NFPA Technical Committee on Chimneys, Fireplaces, and Venting Systems for Heat-Producing Appliances (CHI-AAA) NFPA 211 First Draft Meeting (A2026)

August 26 and 27, 2024
1:00 p.m. – 4:00 p.m. (Eastern) each day

Figure 11.2.5.4 Fireplace Clearance to Combustible Material.

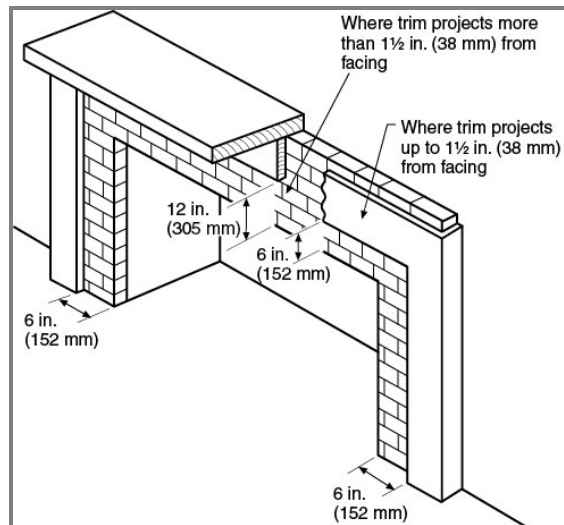
Combustible ~~material above and projecting~~ material projecting more than 1½ in. (38 mm) ~~from off the facing of a fireplace opening~~ shall not be placed less than 12 in. (305 mm) from the top or sides of the fireplace opening. (See Figure 11.2.5.4.)

By adding this requirement for the sides of a fireplace opening, it will be more consistent with the International Residential Code/Building Code. The Standard 211 currently does not have language that prevents a 10" projection 7" from the sides of a fireplace opening. This addition would place a 10" projection or even a perpendicular combustible wall 12" from the sides of the opening.

Figure 11.2.5.4 Fireplace Clearance to Combustible Material.

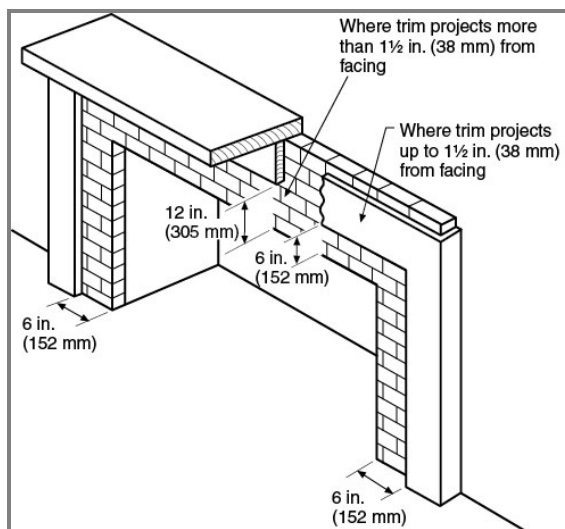
Combustible material ~~above and projecting~~ material projecting more than 1½ in. (38 mm) from a fireplace opening shall ~~off the facing of a fireplace shall~~ not be placed less than 12 in. (305 mm) from the top or sides of the fireplace opening. (See Figure 11.2.5.4.)

By adding this requirement for the sides of a fireplace opening, it will be more consistent with the International Residential Code/Building Code. The Standard 211 currently does not have language that prevents a 10" projection 7" from the sides of a fireplace opening. This addition would place a 10" projection or even a perpendicular combustible wall 12" from the sides of the opening.

Resolution: The proposed changes are new material for this code cycle and is being rejected but held for the next cycle.
